Third Party planning objection vs. South Dublin County Council planning application, reg. ref. SD21A/0271, which proposed development comprising of "Demolition of the existing building on site and the construction of a 5-storey over partial basement, mixed-use development comprising a gastro pub/restaurant with off-licence, 2 retail units, associated bin stores, bike stores, 1 ESB sub-station, all at ground floor level, a small plant room at basement level; a total of 50 apartments (25 one beds and 25 two beds) on the upper floors, all provided with private balconies/terraces; communal roof gardens; car parking; motorcycle parking; bicycle parking; landscaping and upgrades to public realm including upgrades to existing pedestrian crossing on Kennelsfort Road Upper, and all associated engineering and site works necessary to facilitate the development" on lands at The Silver Granite pub, junction of Kennelsfort Road Upper and Wheatfield Road, and at The Silver Granite car park adjoining Palmerstown Shopping Centre car park (accessed from Kennelsfort Road Upper via Palmerstown Park)

Third Party Planning Objection

Third Party planning objection vs. South Dublin County Council plannin

Fig. 1: The Applicant's 'Site Location Map' showing site areas on two sides of Kennelsfort Rd, etc.

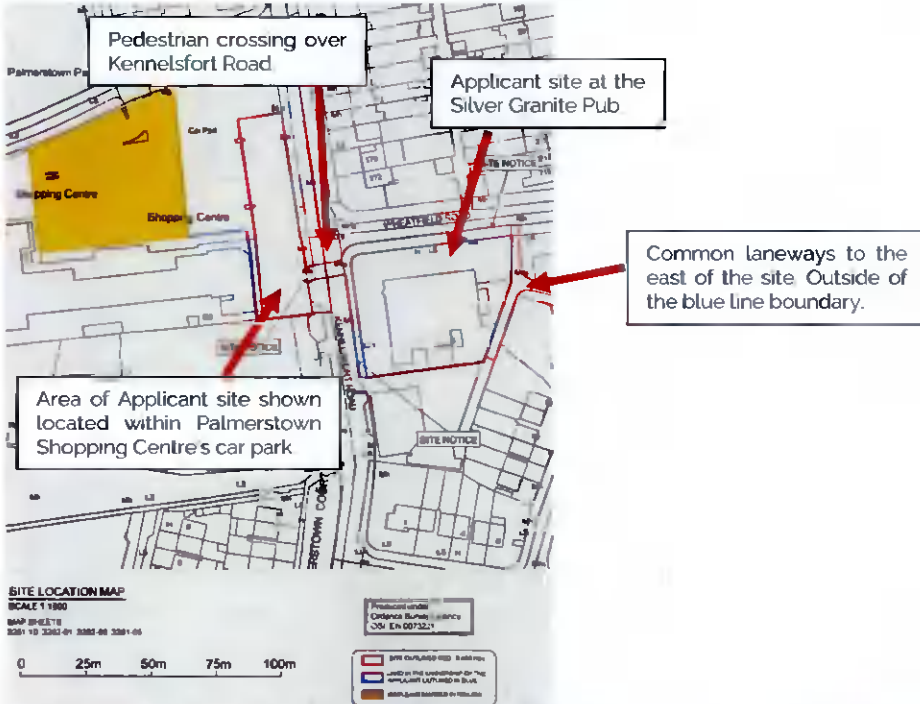
- 1 The Applicant is effectively claiming that The Silver Granite Pub's primary car parking area is located within the Palmerstown Shopping Centre. That the Applicant has provided legal title documents which purport to show how this is the existing parking situation in law, it does not make it any less unusual. It would obviously be the case that pubs such as The Silver Granite Pub benefit from the use of parking areas such as that serving Palmerstown Shopping Centre when they are under less pressure in the evenings and at night, but there is no defined area of car parking within the existing Palmerstown Shopping Centre for The Silver Granite Pub's – the spaces are not marked or delineated in any way. They are Palmerstown Shopping Centre spaces.

- 2 The extent of areas included in this planning application that are not in the Applicant's ownership including laneways to the east, pedestrian paths on the northern and western sides of The Silver Granite Pub, the pedestrian crossing over Kennelsfort Road, etc. all serve to make the available site area on the east side of Kennelsfort Road appear larger than it is.
- 3 The inclusion in this planning application of areas of the Palmerstown Shopping Centre's car park also serves to make the Applicant site appear larger than it is.

It is in fact the case that the Palmerstown Shopping Centre bears little physical or visual connection to The Silver Granite Pub. Kennelsfort Road, low height boundary walls and public footpaths all serve to disconnect these two commercial properties (see Figs 1 to 6).

Fig. 9: Bollards and yellow lines exist to the front of the site to prevent fly parking, etc.

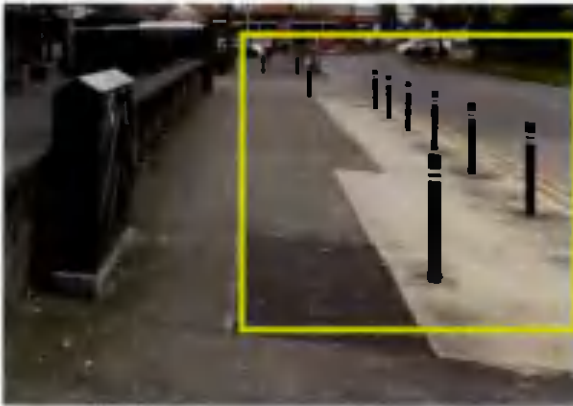
This problem has been addressed by SDCC by way of the installation of yellow lines and bollards beside and on this section of road and footpath (see Fig 9). The bollards prevent vehicles from parking or parking partly on the footpath.

Our client cannot understand how, given this, the Applicant is now proposing to effectively incorporate this footpath into the scheme by way of replacing the footpath with 4 parking spaces, a loading bay and bike parking. This is a backward step and one which does not reflect the parking and traffic issues that arise for many years because of the mis-use of the pedestrian path. None of the Applicant's reports explain the existence of bollards on the existing footpath at this location.

Fig. 14: Applicant proposals for a new vehicular access/service route are outside the blue line boundary

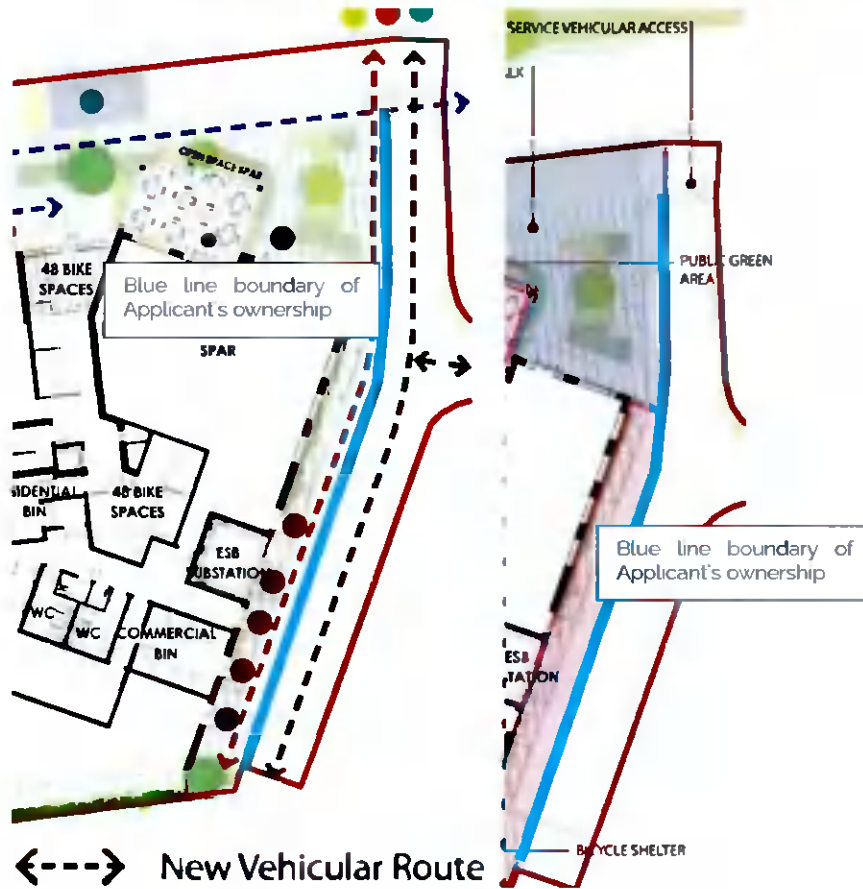
Our client notes the Applicant's intention to remove the existing eastern boundary wall serving their site and to effectively address and make use of the existing laneways to the east of the site. The proposal amounts to the incorporation of the adjoining lane areas into the Applicant's site boundary despite their not owning them. The actual blue line boundary of the Applicant site is shown in Fig 14.

Our client supports the residents of Oakcourt Grove and Wheatfield Road in opposing the inclusion of these laneways into the scheme for, inter alia, vehicular traffic. This proposal should not be accepted in principle and the Silver Granite Pub should continue to maintain a boundary wall to the lanes and should not be allowed to try to effectively incorporate these lanes into their scheme.

Fig. 21: Applicant scheme drawings are misleading as to the site's actual blue line boundary

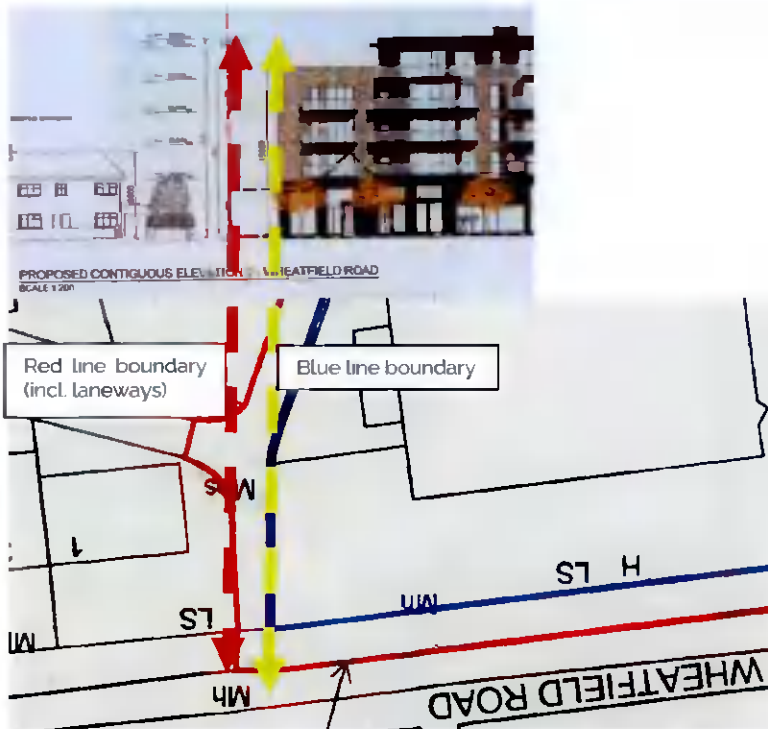
The Applicant has chosen to include the lanes to the east of the site within the red line boundary though they do not own these. They then provide drawings, such as the contiguous elevation shown in Fig. 21 which show the scale of the proposed development relative to the red line boundary. This has the effect of making the eastern boundary of the Applicant's property seem setback further than it is. The lanes to the east actually appear to be the setback provided by the Applicant when they are not.

The Applicant building should be setback from its blue line boundary and not from the red line boundary line which includes the laneways to the east.

The result of the laneways being incorporated into the Applicant site is that the proposed building has been sited too close to the residential properties located to the east. The proposed building needs to be setback from the laneways thereby increasing the setback to these properties.

Fig. 30: Scheme's communal open spaces impact negatively on future residents' amenities

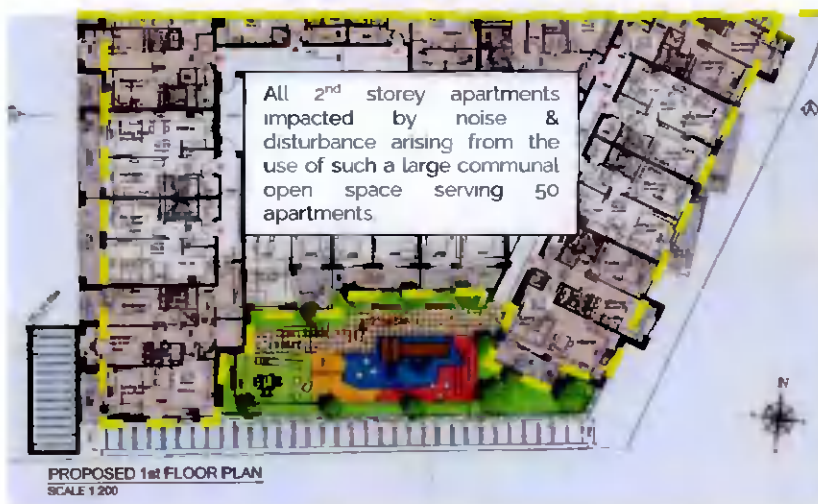
Our client submits that the proposed communal open spaces are not acceptable from a future amenity perspective for residents of the scheme. The scheme needs to offer improved public and communal open spaces for its residents. It may need to offer internal amenity areas.

Fig. 36: Existing emergency entrance/exit shown as opened as an Applicant scheme exit

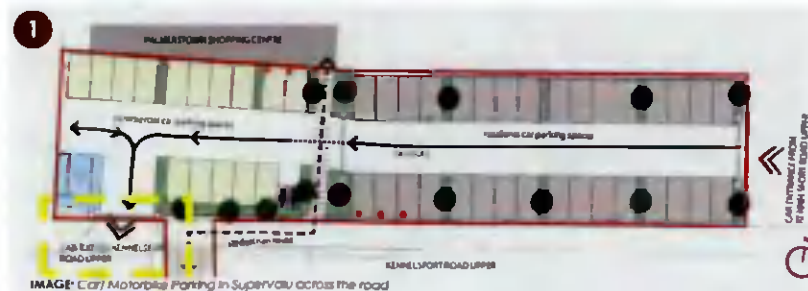
For the above reasons, our client strenuously objects to the Applicant proposal to open the existing shopping centre's emergency entrance/exit such that the proposed development's staff, customers and residents can always use it as an exit

Fig. 38: Existing & proposed arrangements for the large public footpath on the north side of the pub

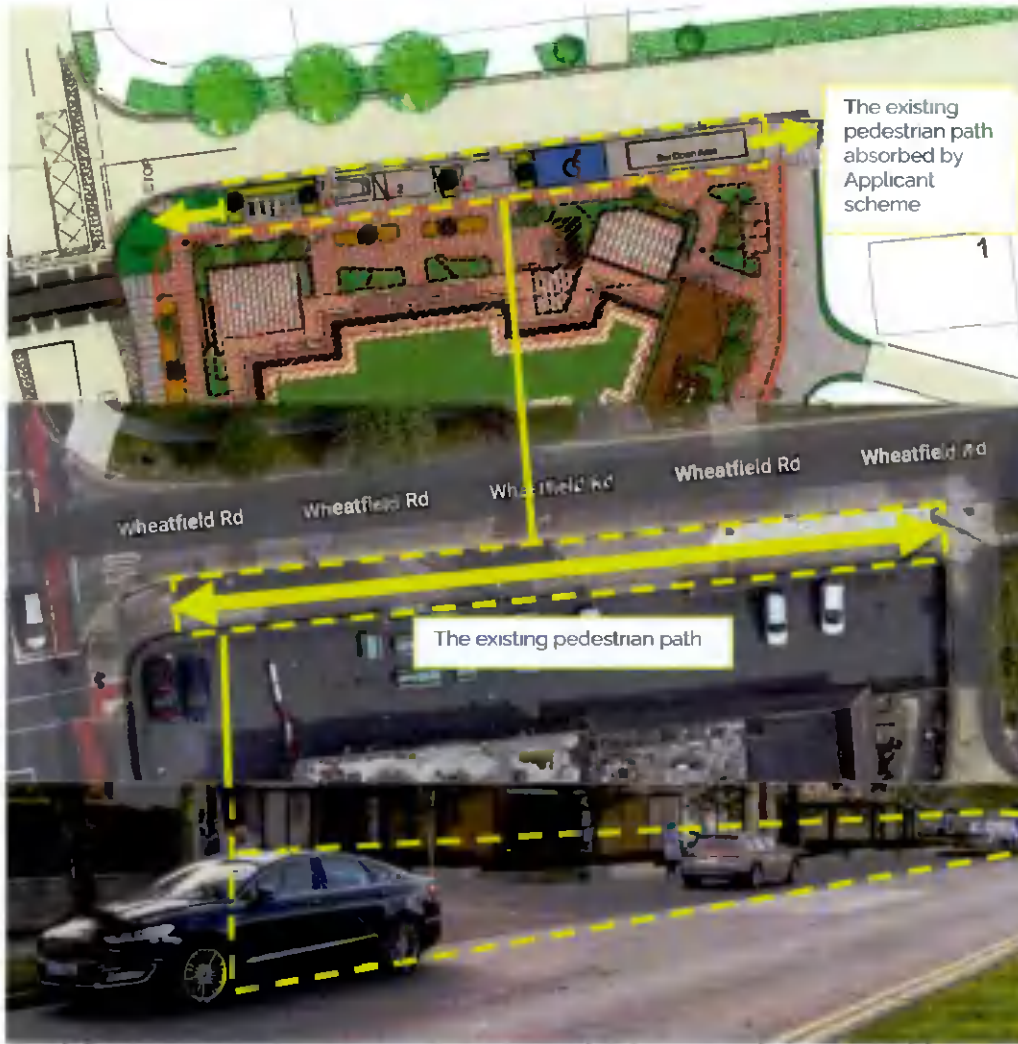
These proposals confirm the Applicant scheme as overdevelopment of this site wherein they cannot even manage to find space on the site to provide 4 no. parking spaces, bike parking spaces and a bike parking area. Instead, the development needs to spill out onto the public footpath.

This proposal cannot be permitted in the manner by which it has been submitted. It would set a poor precedent for the incorporation of public footpaths into private development schemes. While it is acknowledged that a footpath is proposed to be provided within the red line boundary it must reasonably be pointed out that this would place the footpath within privately owned lands which is not acceptable. There should be clear delineation within this cheem between private and public lands.

Fig. 41: Proposed loading bay on existing public footpath

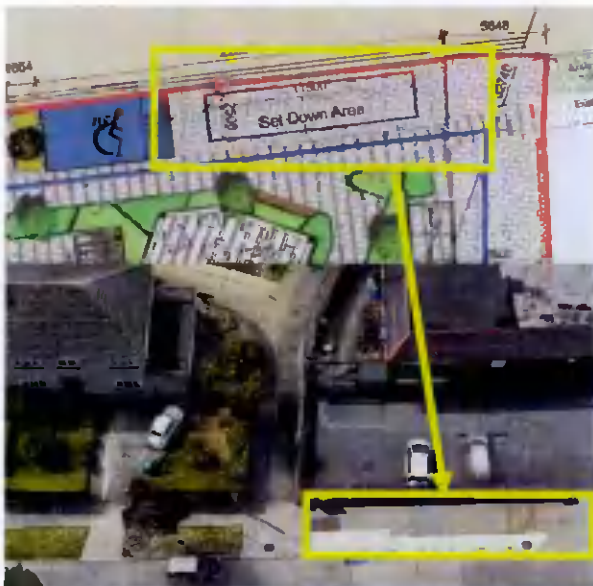
BPS notes here how arising from the proposed ground level external design - which removes all vehicular access to what is the existing perimeter car park that serves The Silver Granite pub - this loading bay would be forced to accommodate 'all' loading to the commercial parts of this scheme and likely all moving trucks, etc. This proposal is wholly unacceptable regarding its likely impacts on the public domain

Para. 212 refers to how this loading bay will be served by "small transit vans or small-wheelbase trucks". Our client does not find this credible. The loading bay will also have to accommodate HGVs and any delivery vehicle that arrives and these will need to turn within Wheatfield Road which is a residential road. These vehicles should be accommodated within the site

Fig. 44A: Area within blue line boundary where surface car parking provision can be provided

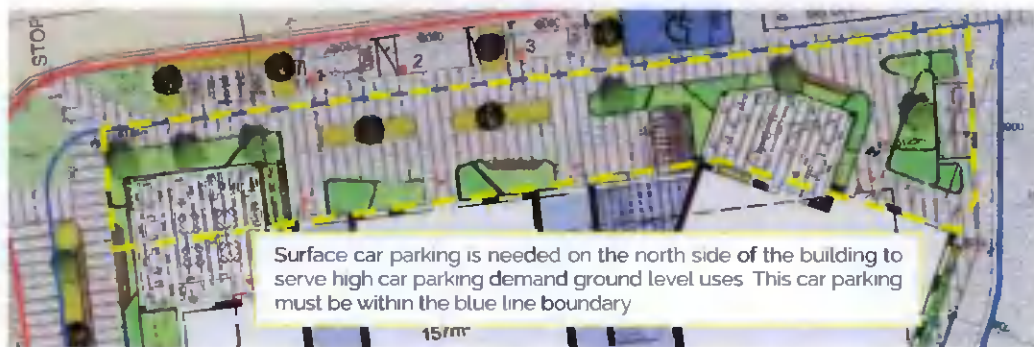
The scheme needs to be re-designed and sited in order to offer substantial ground level car parking on the north side of the proposed building. Decked open bar and cafe areas are shown somewhat gratuitously on the submitted drawings and these need to be removed.

The Applicant should be required to provide surface car parking at this location.

Fig 45: Areas of proposed cycle parking

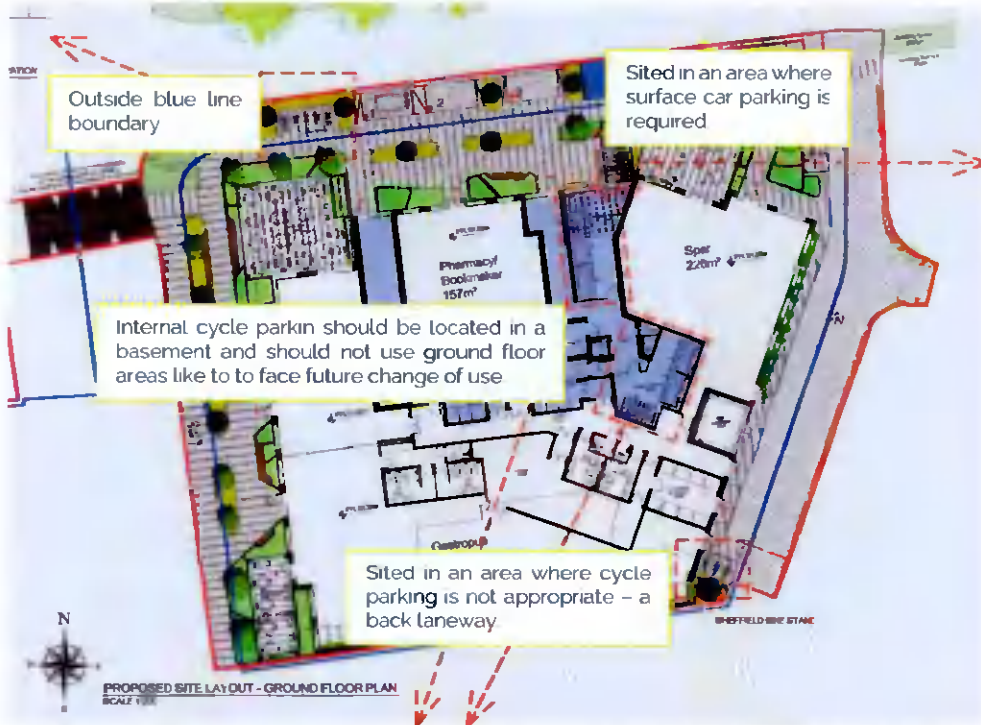
proposal arises because the Applicant has not provided a basement car park within which internal bike parking could also be provided. The ground floor bike storage area takes up valuable ground floor area which could be better allocated.

The proposed cycle parking areas, as set out above, are piecemeal. The Applicant should provide a basement with car and bike parking in which internal covered bike parking would be provided. External cycle parking spaces need to be better sited and on land within the blue line boundary.

Fig. 46: Applicant proposal to open the lanes to the east to traffic is not acceptable

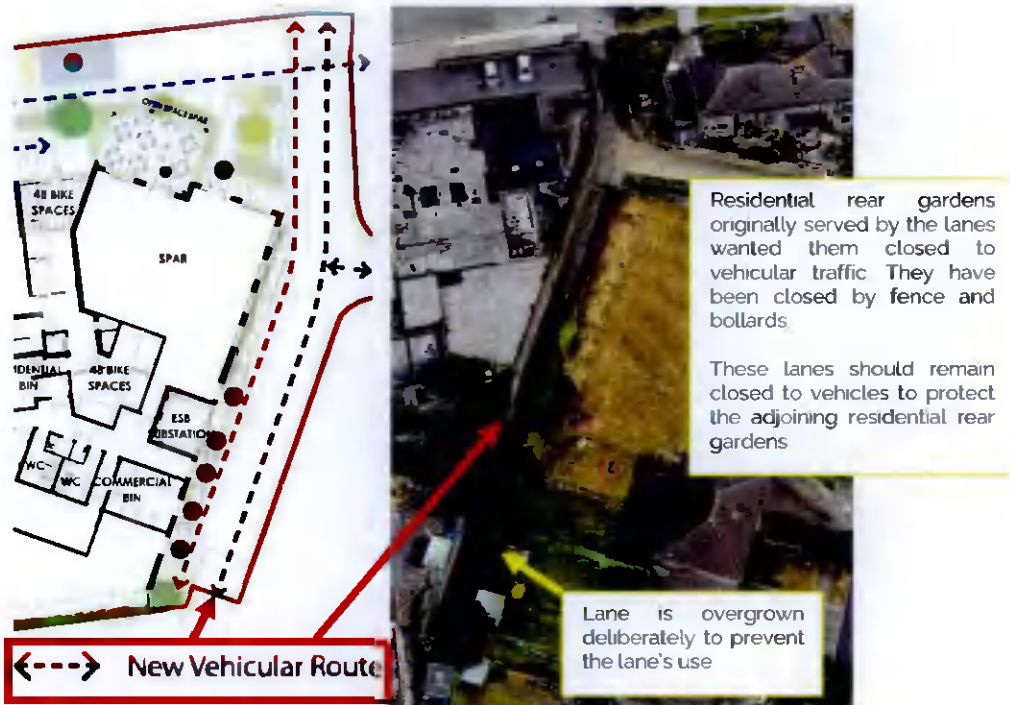
Our client supports the residents of Oakcourt Grove and Wheatfield Road in opposing the opening of these laneways to vehicular traffic. This would have a negative impact on the residential and visual amenities of these residential properties and their rear gardens.

The Silver Granite Pub should continue to maintain a boundary wall to the lanes and should not be allowed to try to effectively incorporate these lanes into their scheme.

Fig. 60: Scheme's Elevation 2 creates a 77.92m shadow at 12 noon on 21st December

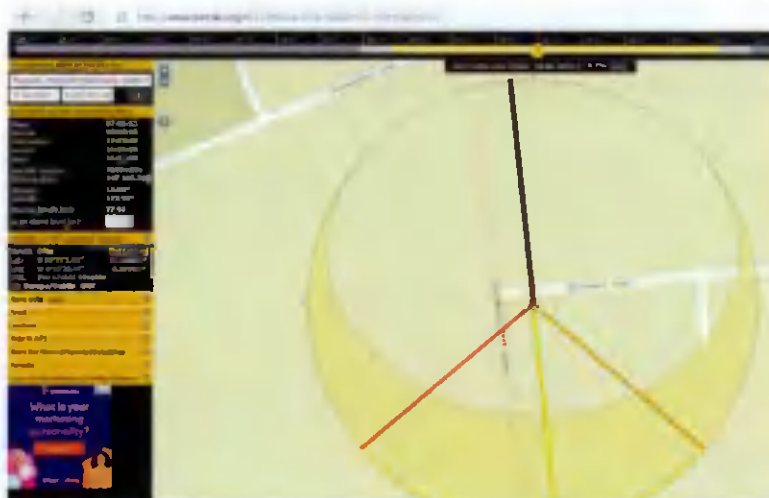
- 2 From 9am to sundown on December 21st, the proposed 18.1m tall building would cause overshadowing and darkening of residential properties to the north including of Nos 172 Kennelsfort Avenue and 215A Palmerstown Avenue. This overshadowing would be experienced worst at midday (see Fig. 60)

BPS considers that the proposed building is too tall and too close to residential properties to the north. The heights of the building and the close proximity result in moderate to significant and negative overshadowing impacts on Nos 172 Kennelsfort Avenue and 215A Palmerstown Avenue and other residential properties further to the north at different times of the year.
